UNITED STATES PATENT AND TRADEMARK OFFICE

APPLICATION NO.	FILING DATE	FIRST NAMED INVENTOR	ATTORNEY DOCKET NO.	CONFIRMATION NO.
10/666,044	09/19/2003	Valery Migachyov	1005.1110103	6577

Office Action Summary

DETAILED ACTION

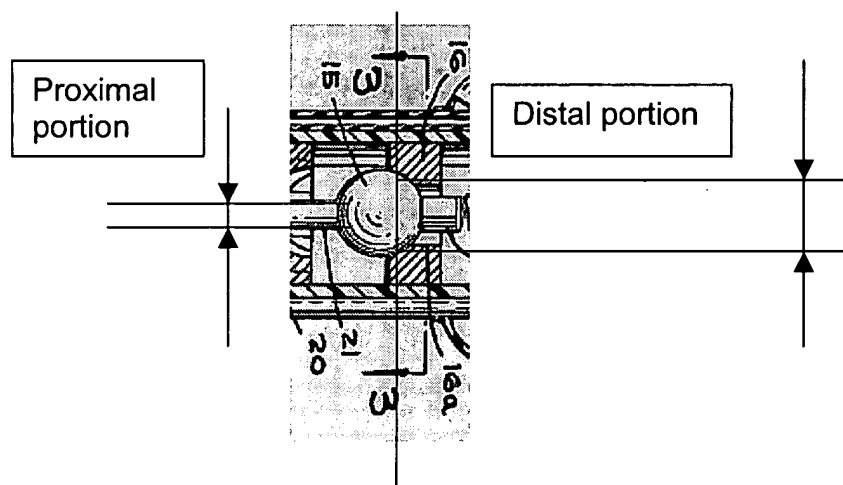
4. **Claims 20- 25, 29-33, 35, 38-40 and 44-47** are rejected under 35 U.S.C. 102(b) as being anticipated by Isaacson (US 3,812,841) cited by Applicant. Isaacson ('841) teaches a valve for a bladder control device, comprising:

an elongate housing (12) having a proximal end, a distal end (Figures 1 and 2), and a valve lumen (16a) extending therethrough,

said valve lumen (16a) including a first lumen portion defining a first lumen diameter, a second lumen portion distal the first lumen portion defining a second lumen diameter greater than the first lumen diameter, and a third lumen portion distal the second lumen portion defining a third lumen diameter less than the second lumen diameter;

a valve seat (16) disposed within the housing (12);

a stopper (15) disposed within the housing (12) and moveable between a first position engaging the valve seat (16) and a second position disposed distally of the valve seat (16) (Examiner considered "a first position"

depicted on Figure 2 at the distal end of the second lumen; and "a second position" depicted on Figure 2 at the distal end of the second lumen), said

the valve of claim 20 and 35, wherein the valve lumen (16a) tapers along a slope between the second lumen portion and the third lumen portion (Examiner considered that a portion between the second lumen and the valve lumen (16A), where the stopper (15) is contacting the valve seat as tapering as depicted on Figure 2);

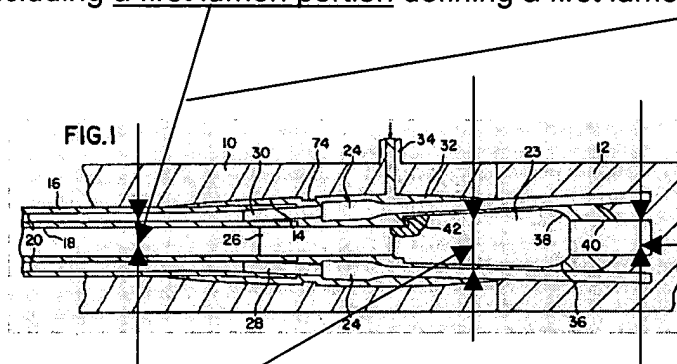
the valve of claims 29 and 44, wherein the spring (17) is under greater tension loading when the stopper is in the second position than when the stopper is in the first position (Figure 2 and column 3, lines 3-16);

the valve of claims 20 and 35, wherein the spring (17) is disposed distally of the stopper (15) (Figure 2);

the valve of claim 20, further comprising an elongate shaft portion (15a) coupling the spring (17) to the stopper (15).
